SITE PLAN & CONDITIONAL USE PERMIT (CUP) APPLICATIONS

4/8/28 Plan Commission Meeting

Crew Carwash / Nomies Investments LLC

Staff Report & Recommendation

CIVIL GRADING AND EROSION CONTROL PLAN

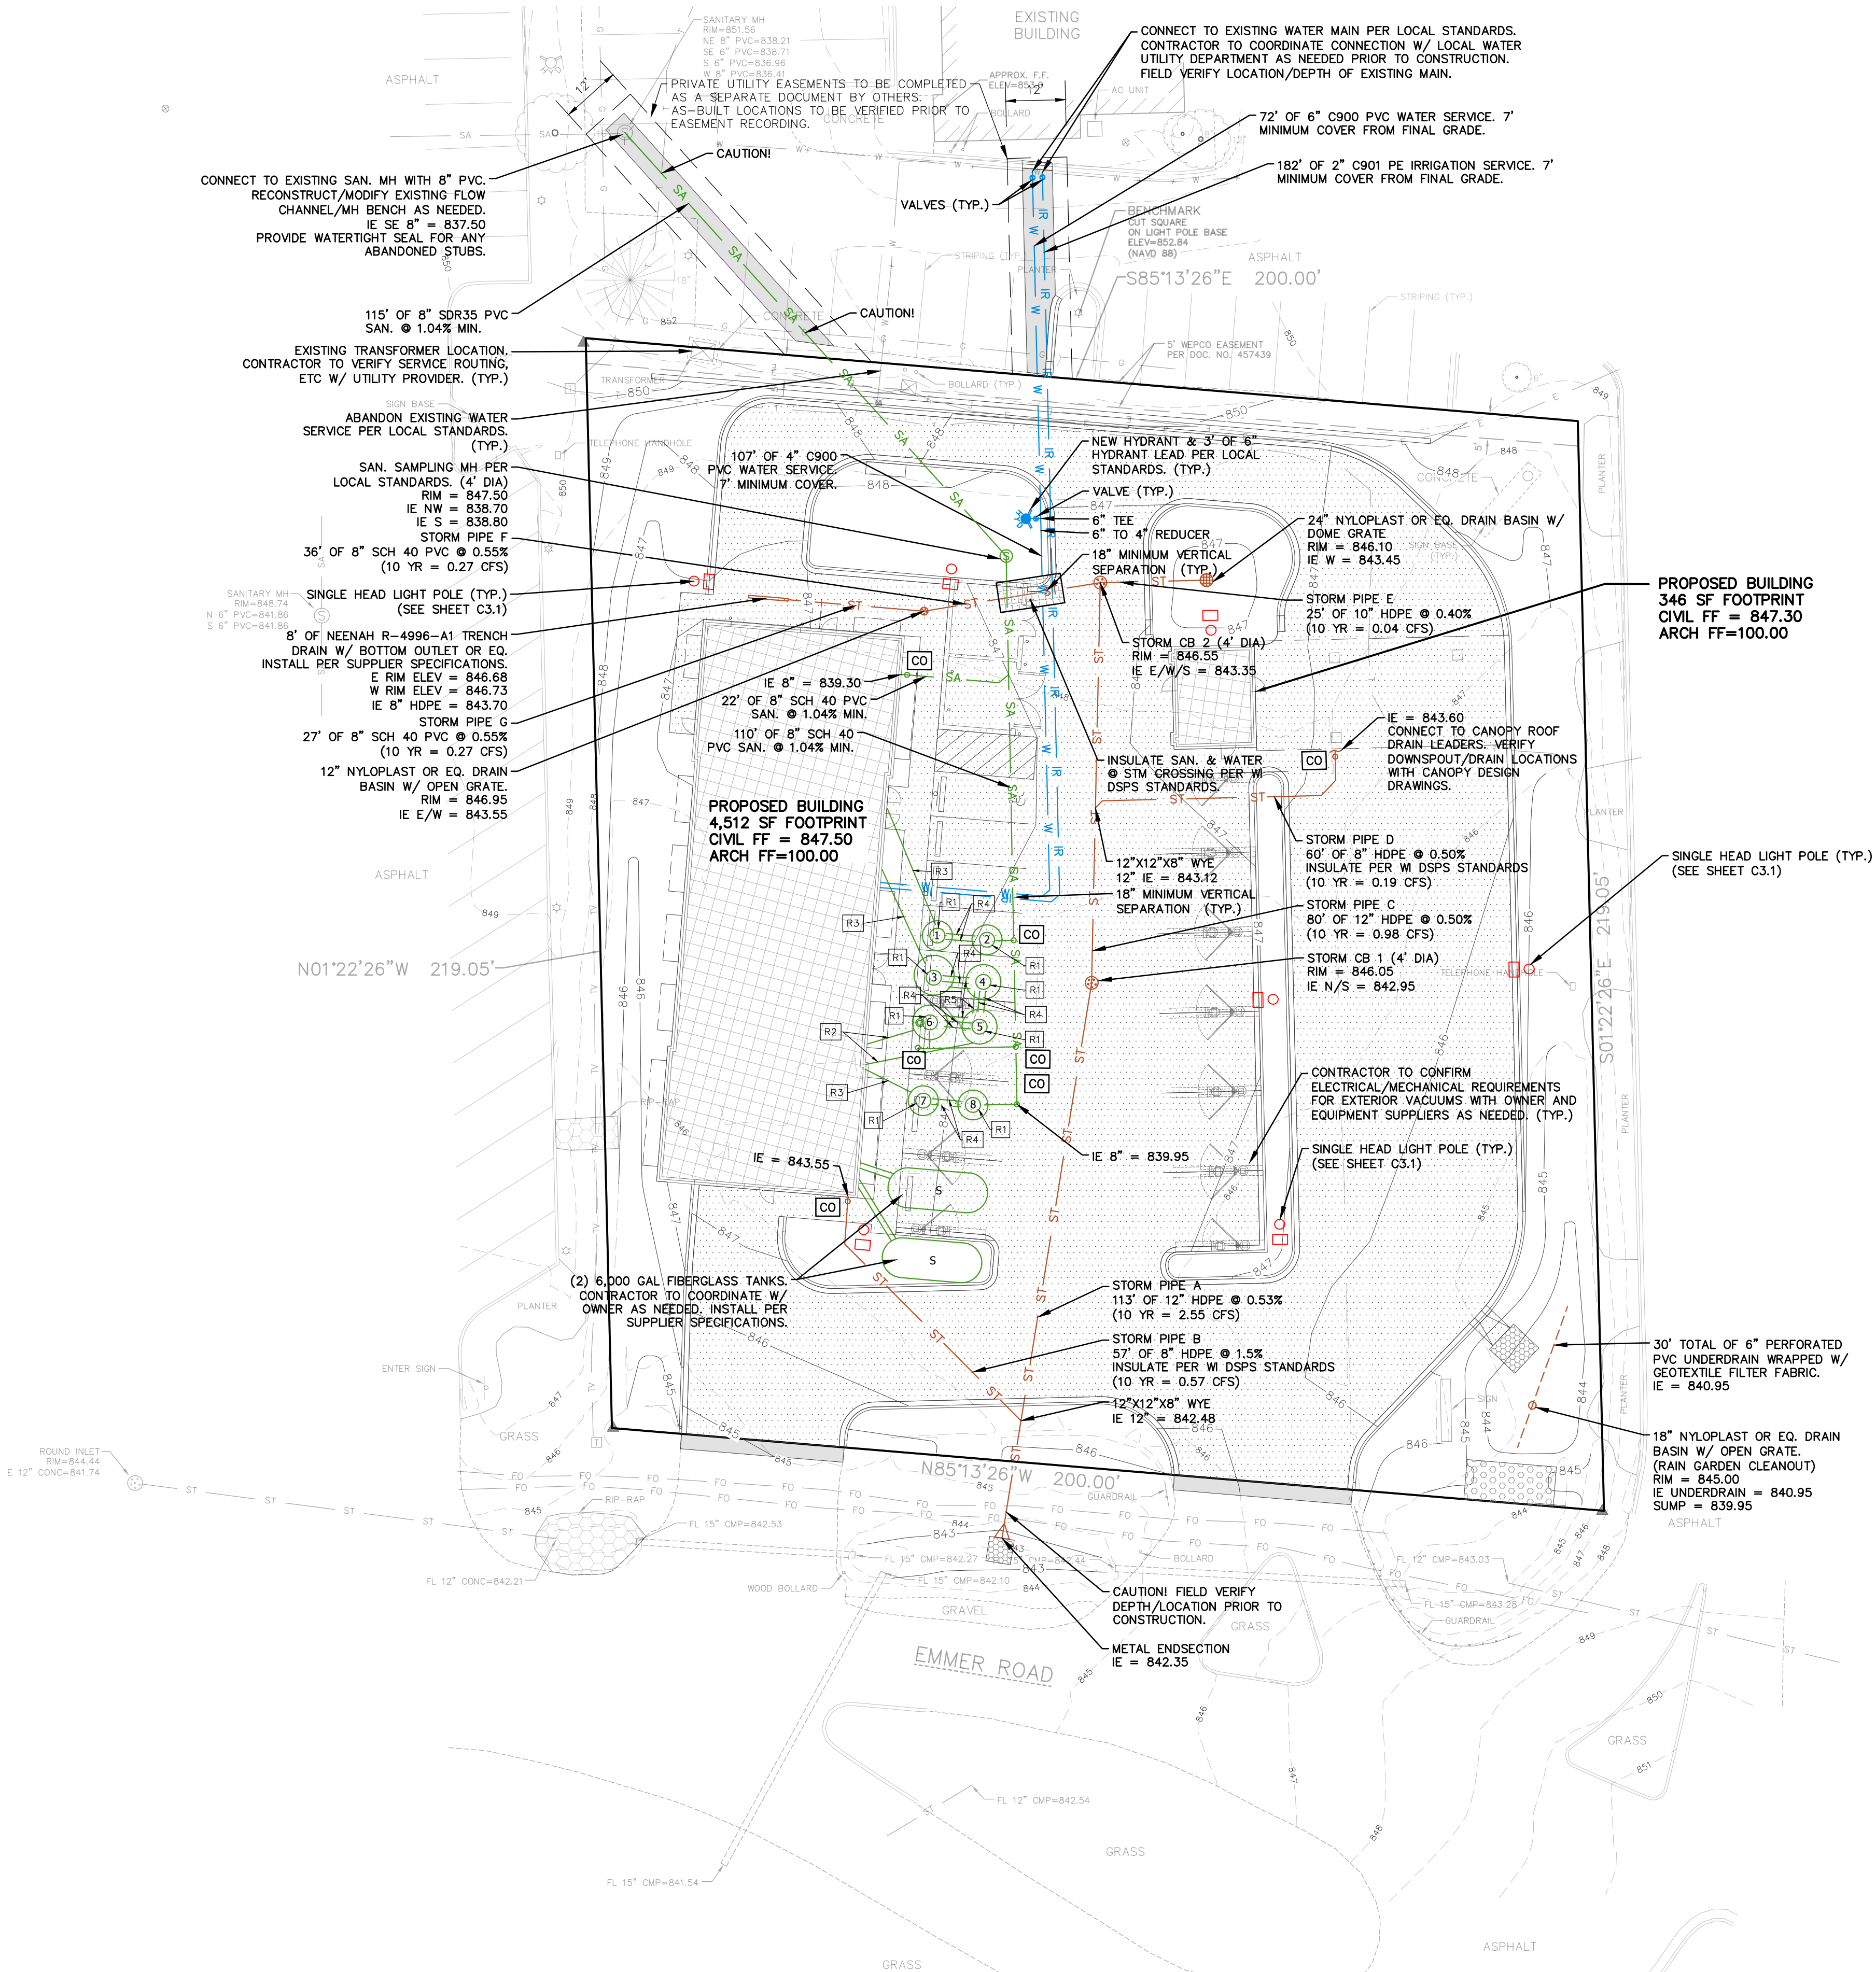
1. Include disturbance in the ROW and utility installation to the north and confirm the disturbance remains under 1 acre.
2. Drainage area to proposed rain garden exceeds the max allowed per WDNR technical standard 1009. Adjust to meet technical standard requirements or add a piped outlet.

CIVIL UTILITY PLAN

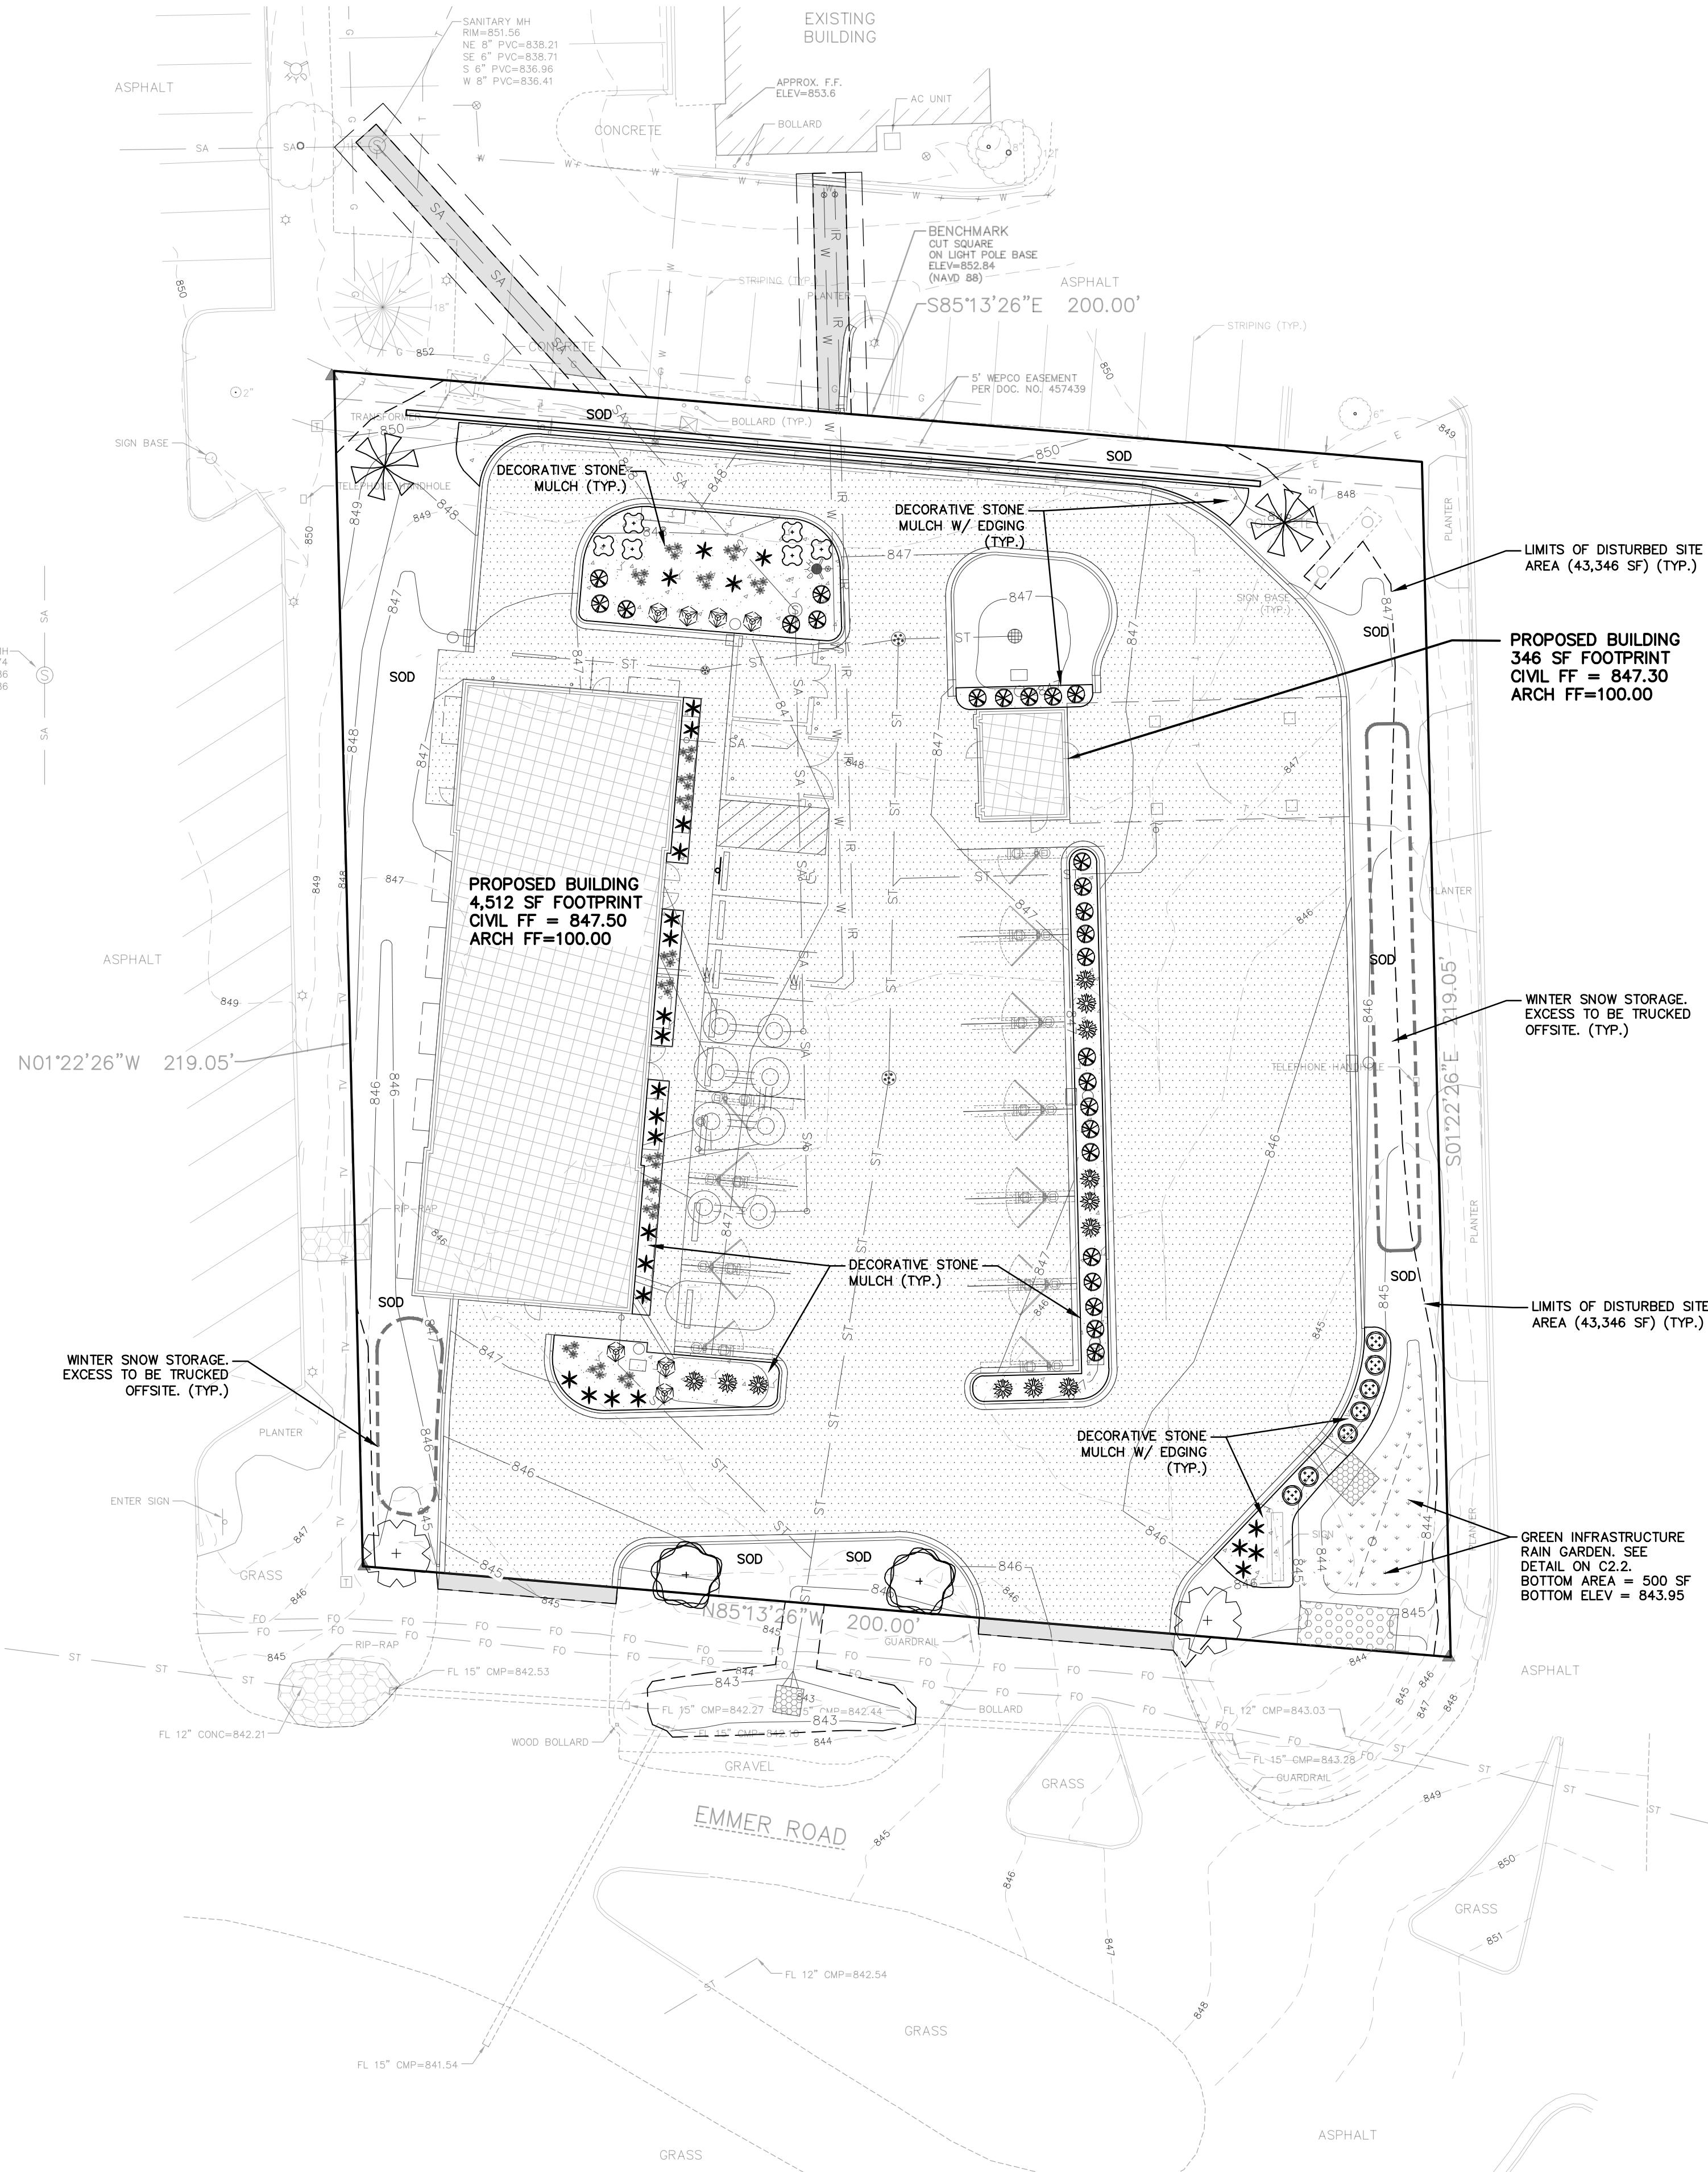
1. Sheet C1.3, Explain the need for a separate sprinkler line. Normal set up is one line and the sprinkler is split off in the mechanical room.
2. Sheet C1.3, describe the dash lines around the sewer and water lines, just making sure this is not a reference for a utility easement.

3. We will require a review of the meter room for adequate space and installation requirements.
4. Call out gate valve to be Mueller onto a 8" x 6" Tapping saddle with a S.S. MJ spigot outlet.
5. Remove existing water lateral from the water main, install a full circumference Hymax repair clamp over CC tap hole. minimum 8" x 20"

1. Copies of executed sewer and water easements are required prior to engineering plan approval.
2. Add a trench drain at the exit of the car wash to capture water before draining to the ROW.

TREE PLANTING DETAIL
NO SCALE

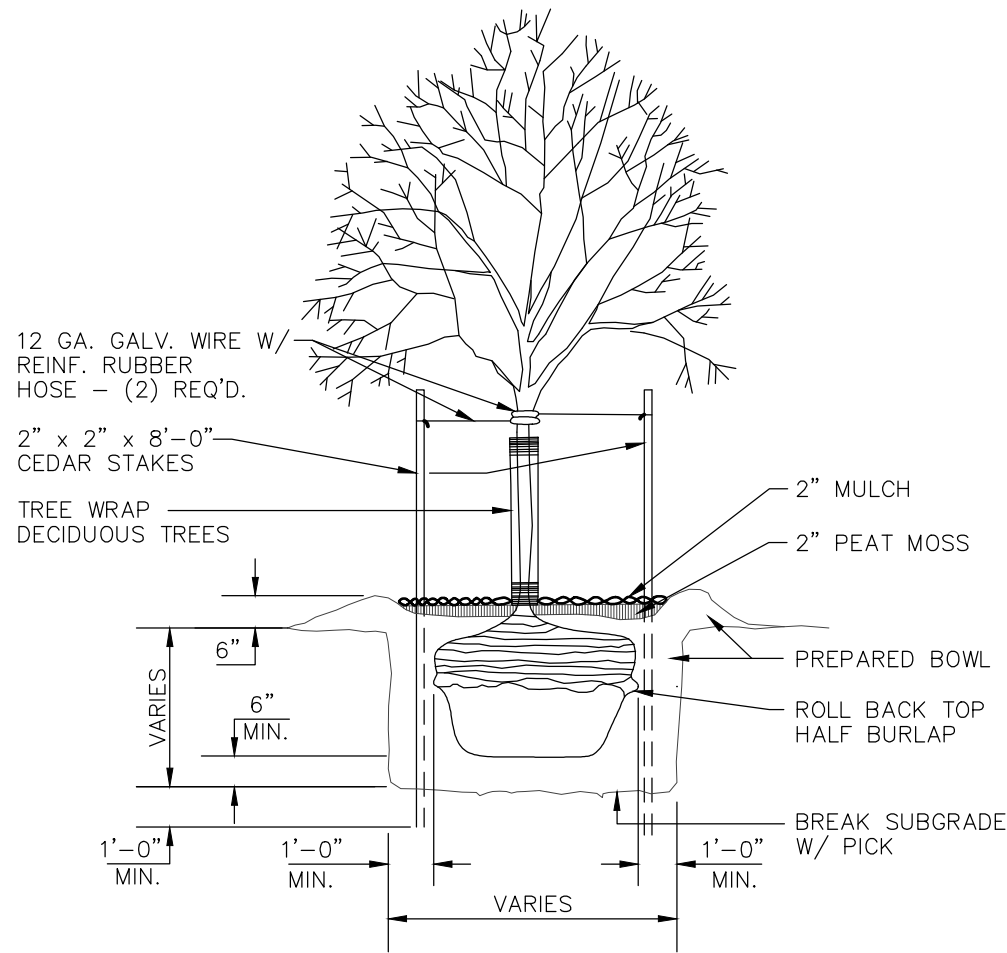
- Tree planting detail image revision on sheet C1.4: Include that root flare should be left exposed, moss/mulch line should be at or just below top of root ball.

3. The mulch in the landscaping beds shall be wood mulch and not decorative stone.
4. Tree planting detail on sheet C1.4 shall be revised to include that root flare should be left exposed, moss/mulch line should be at or just below top of root ball.
